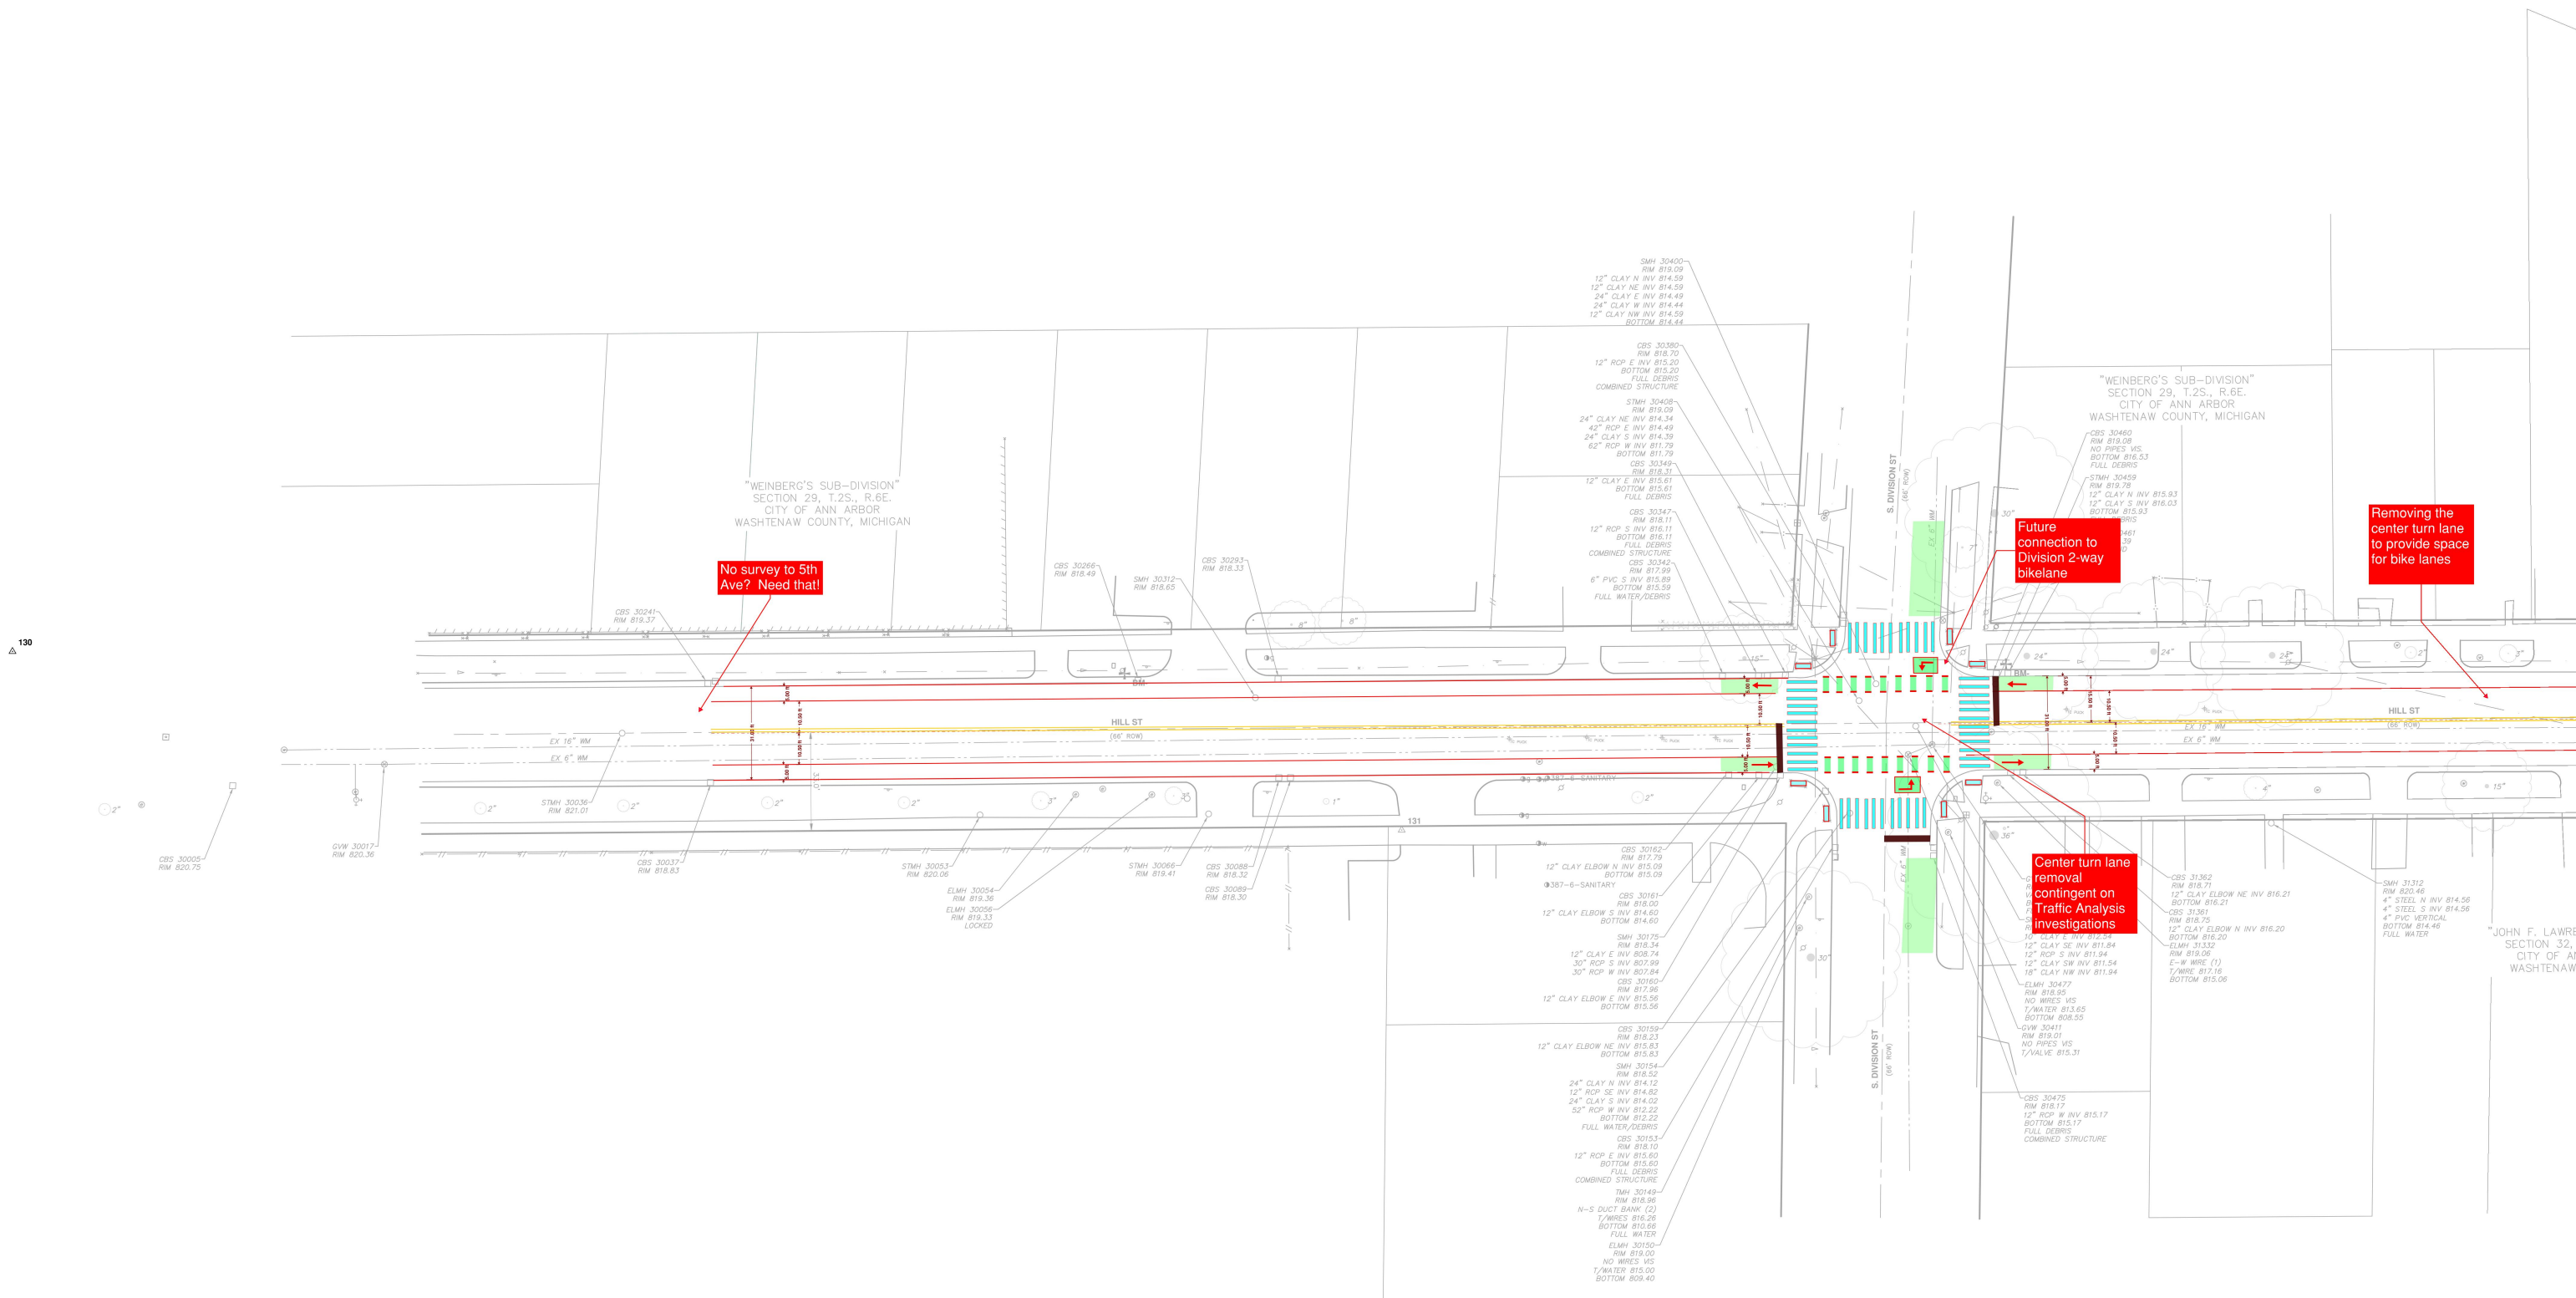
No survey to 5th Ave? Need that!

Future connection to Division 2-way bikelane

Removing the center turn lane to provide space for bike lanes

Center turn lane removal contingent on Traffic Analysis investigations

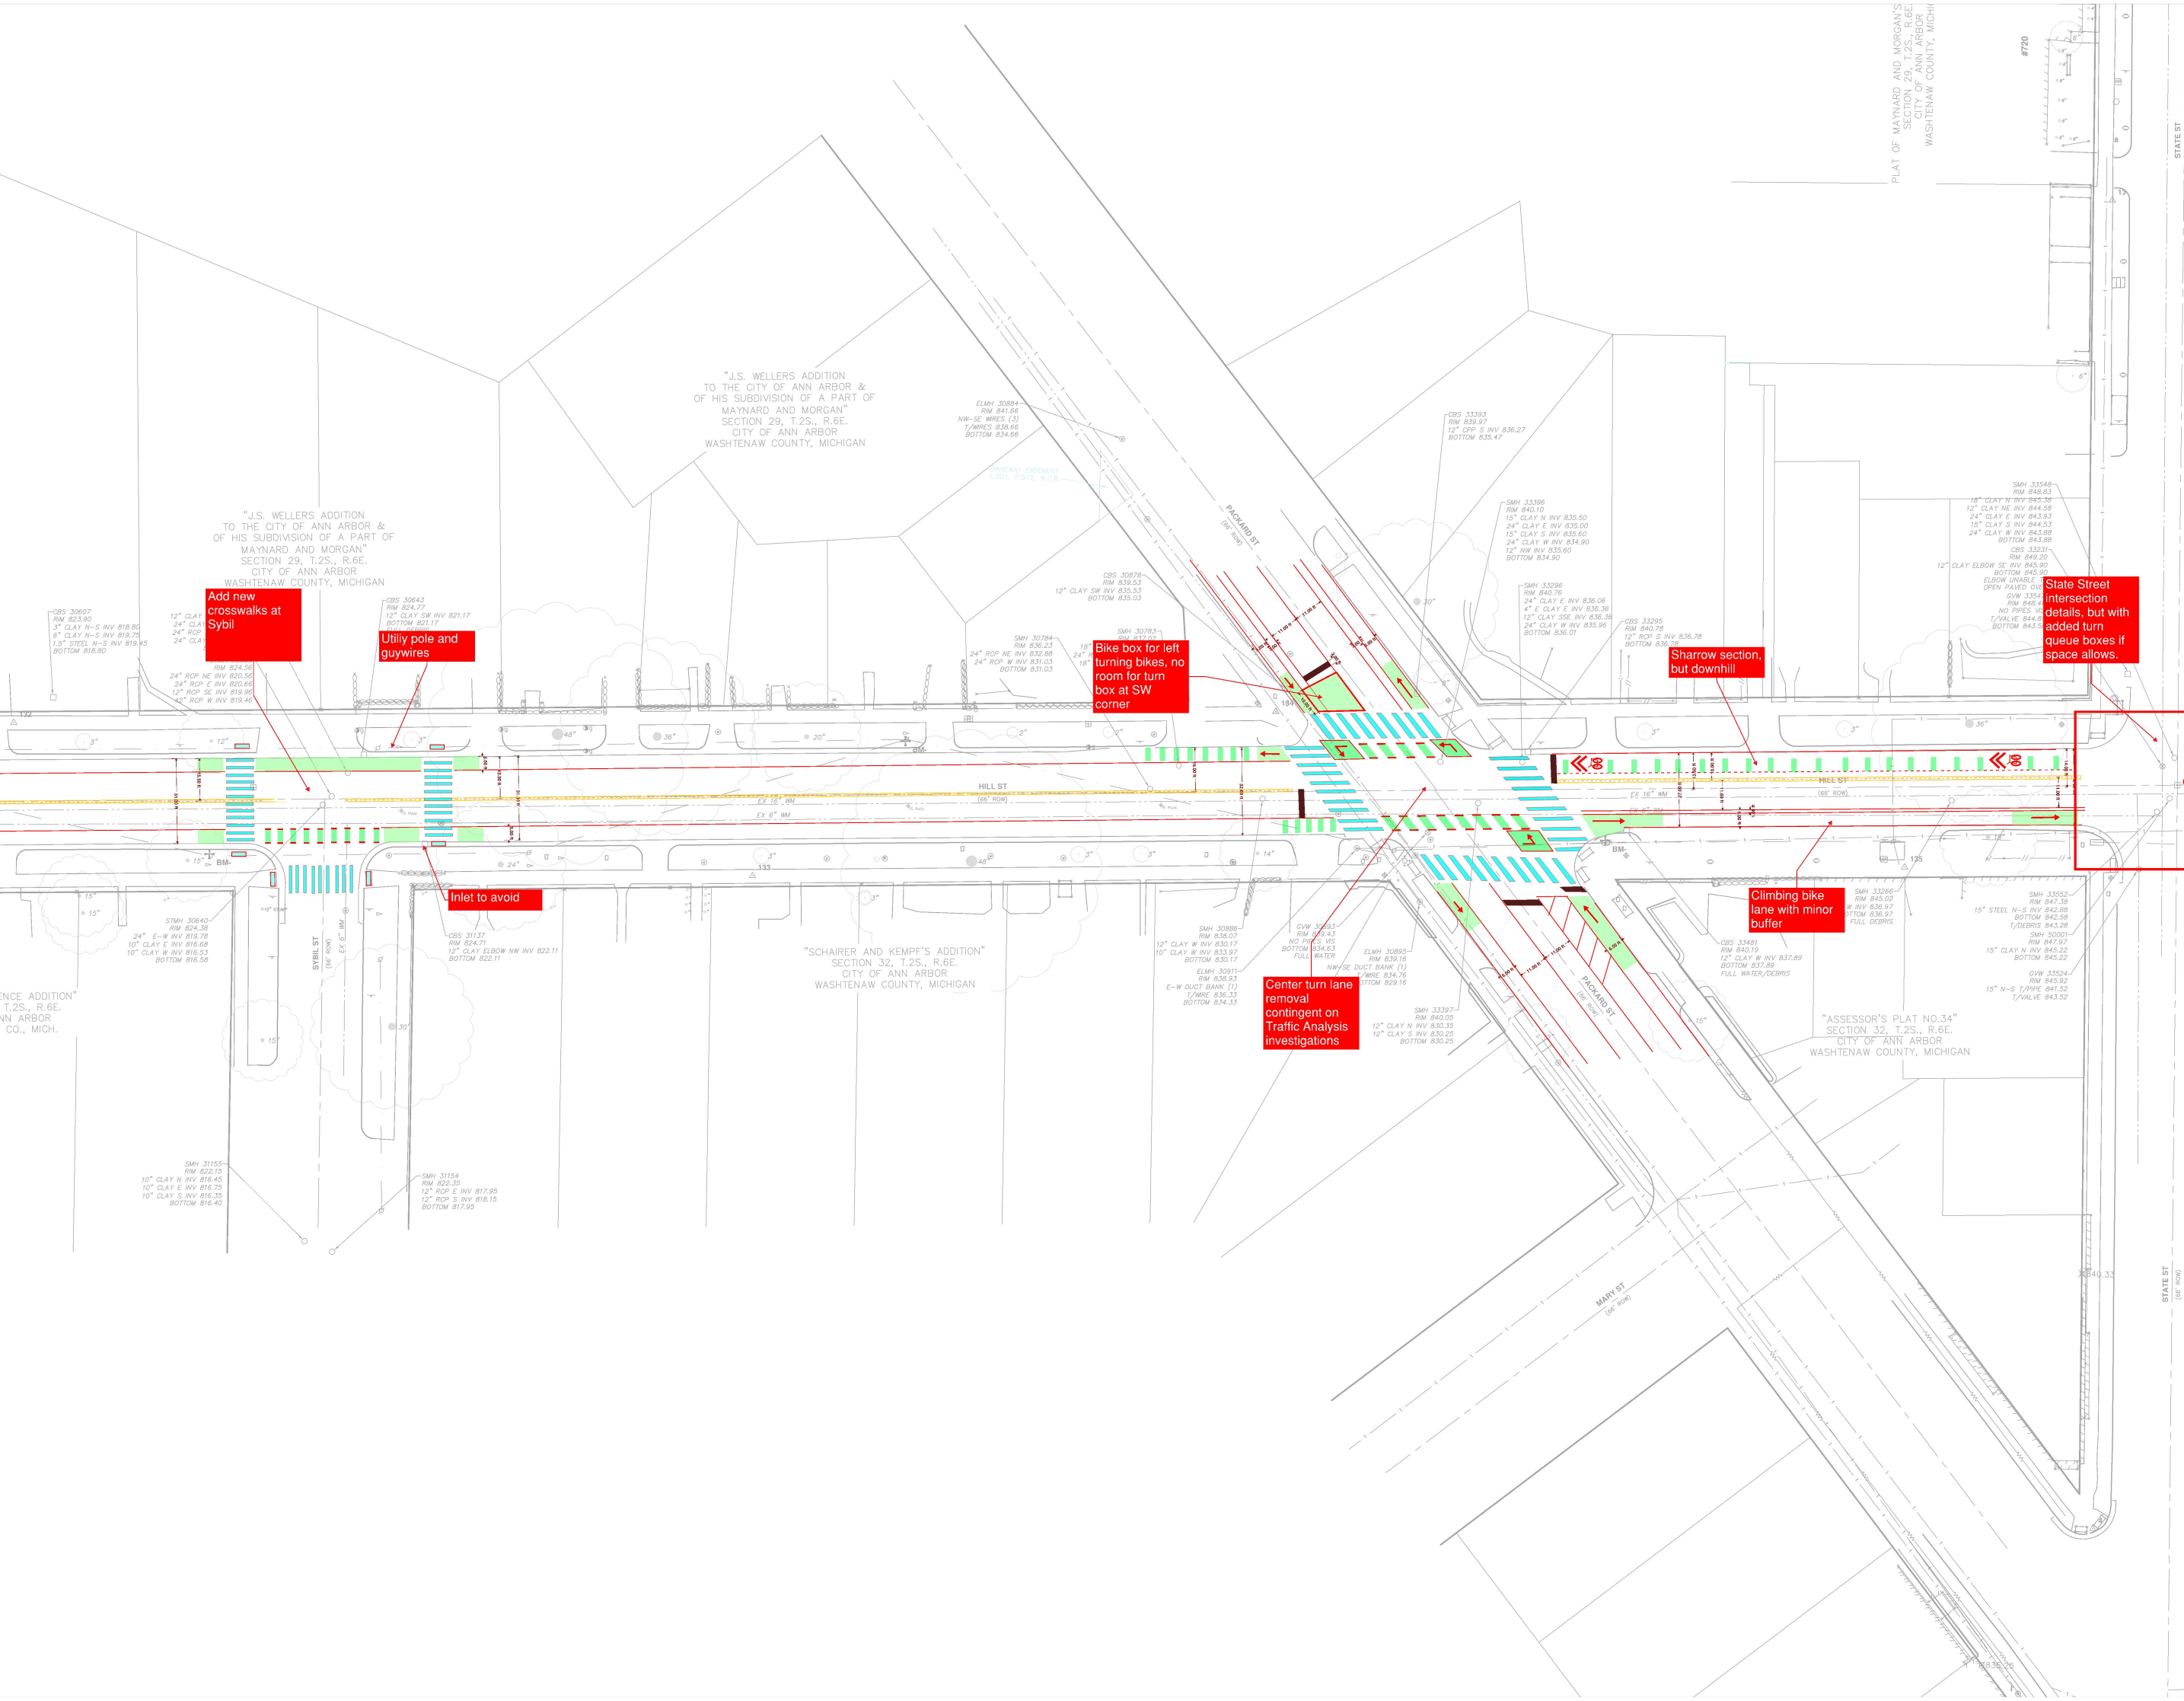
Add new crosswalks at Sybil

Utiliy pole and guywires

Bike box for left turning bikes, no room for turn box at SW corner

Sharrow section, but downhill

State Street intersection details, but with added turn queue boxes if space allows.

Inlet to avoid

Center turn lane removal contingent on Traffic Analysis investigations

Climbing bike lane with minor buffer

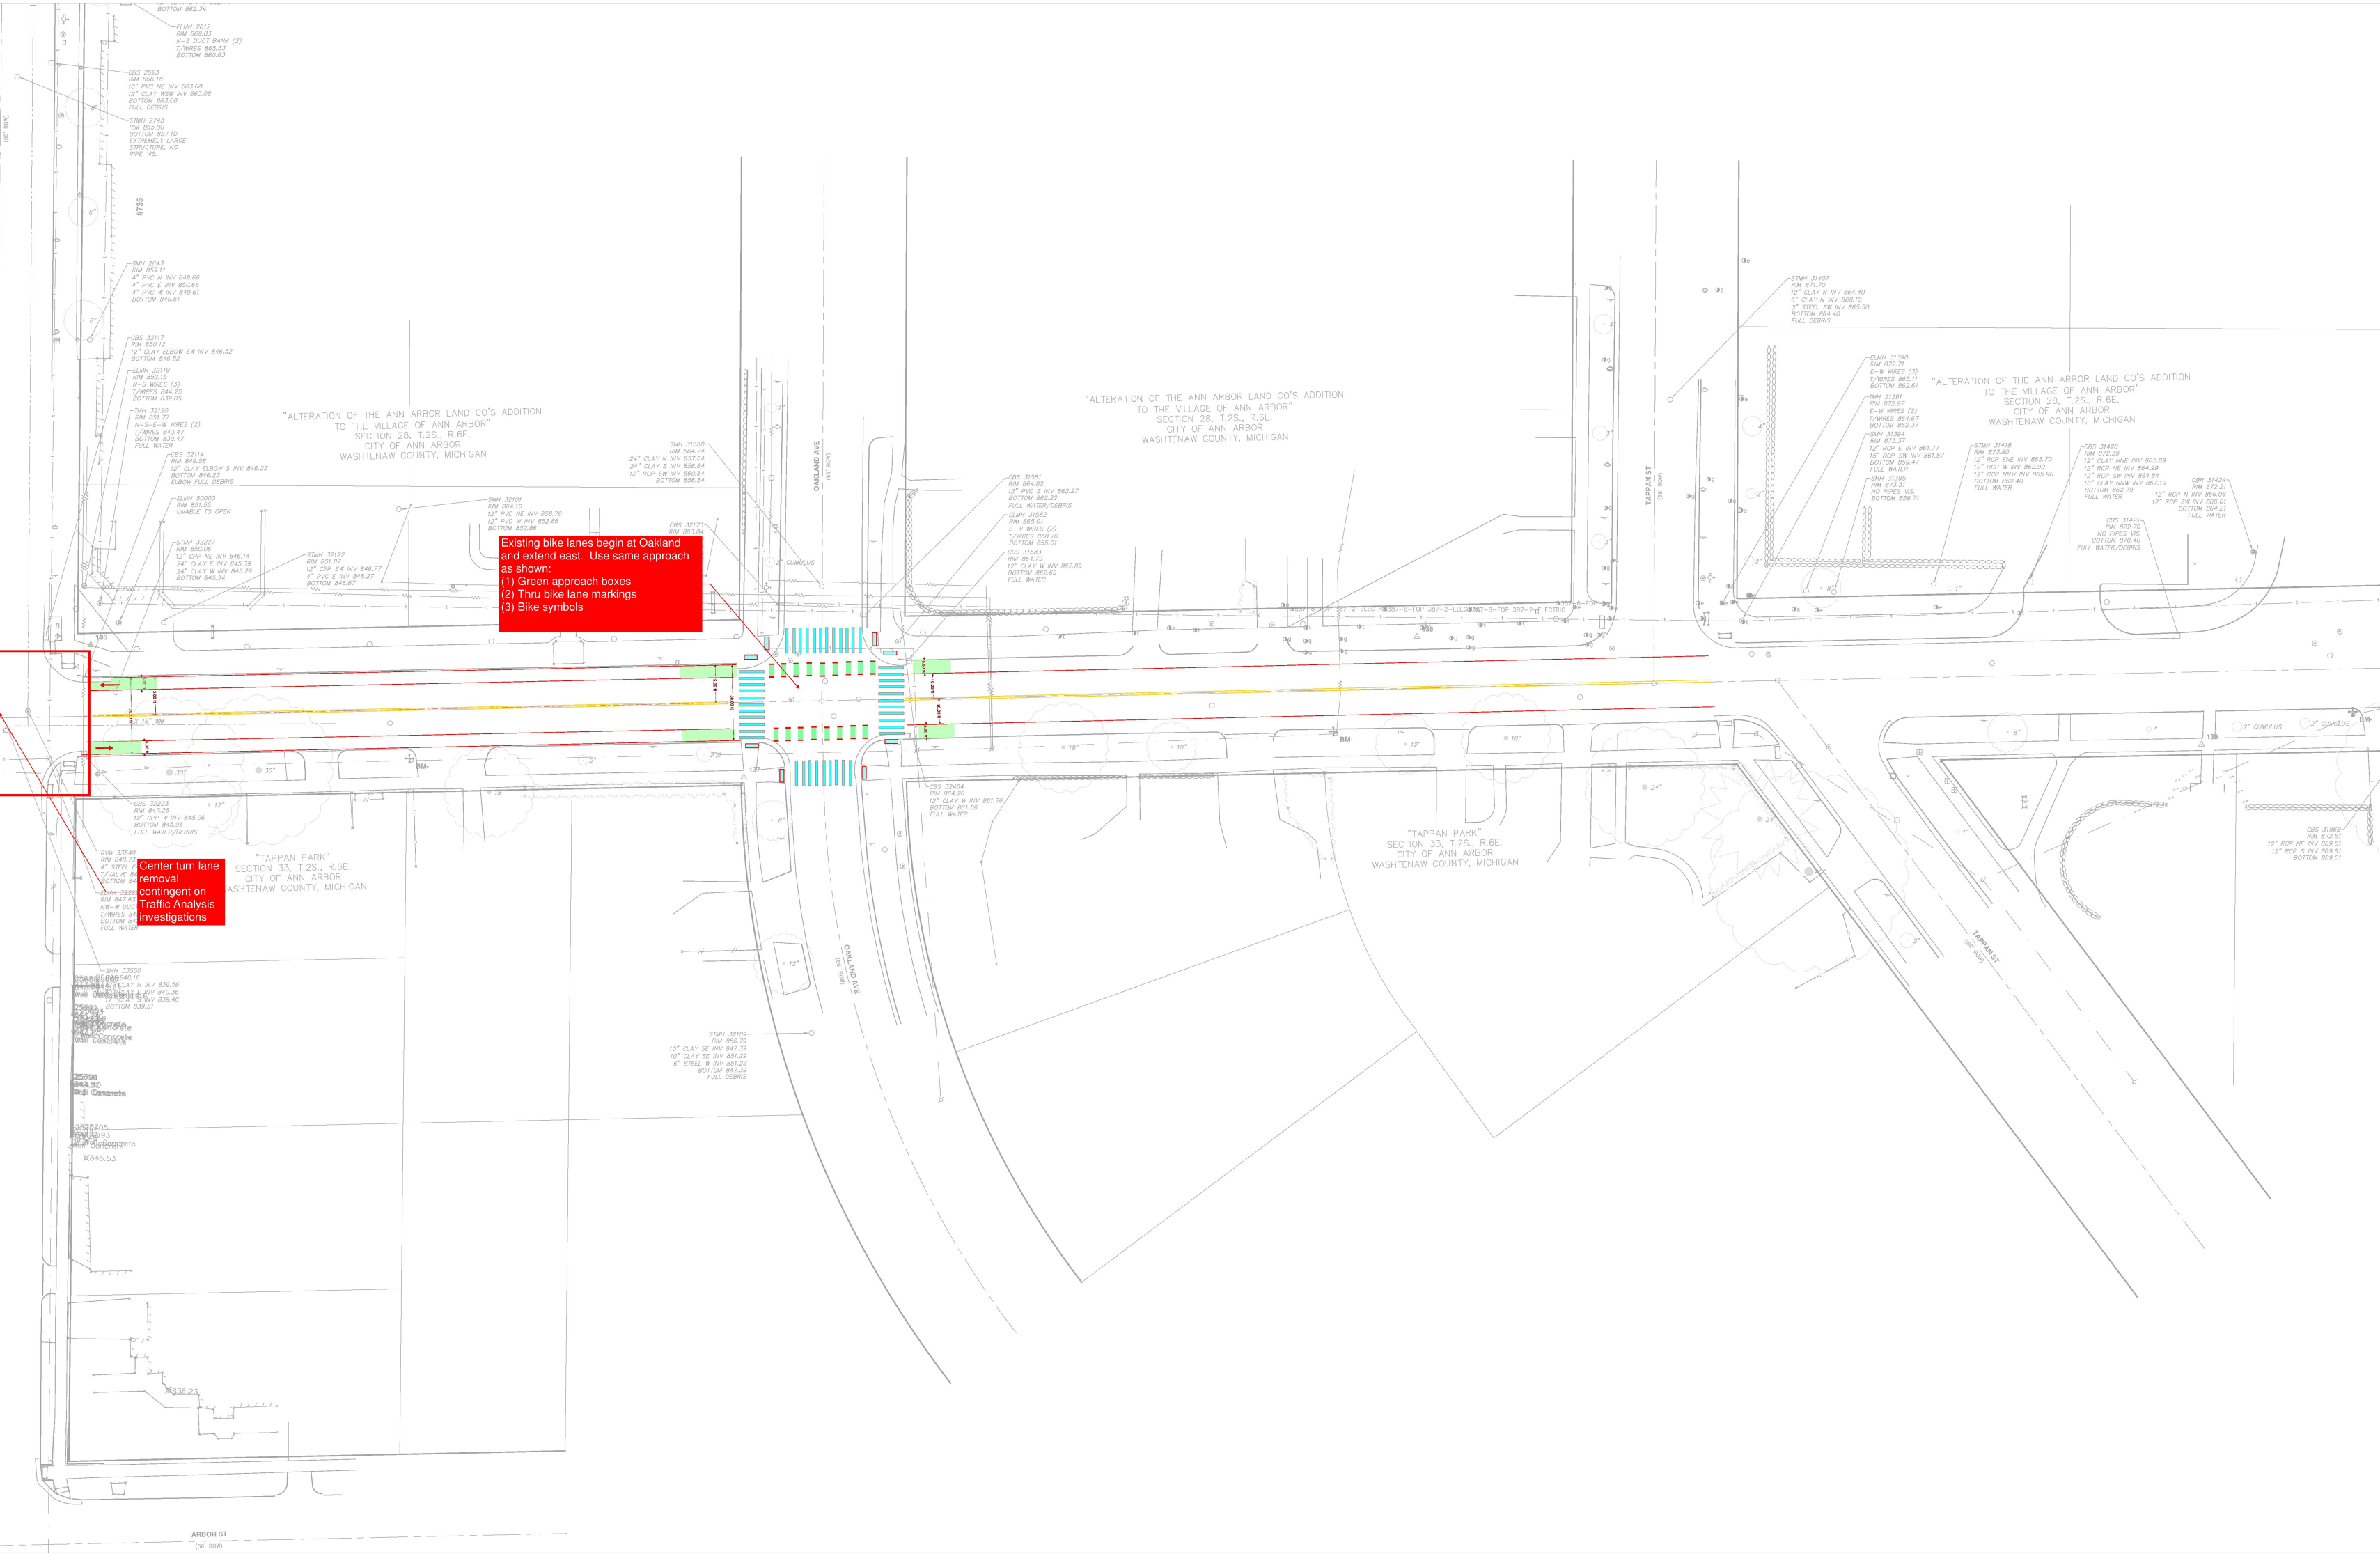
Existing bike lanes begin at Oakland and extend east. Use same approach as shown:
(1) Green approach boxes
(2) Thru bike lane markings
(3) Bike symbols

Center turn lane removal contingent on Traffic Analysis investigations
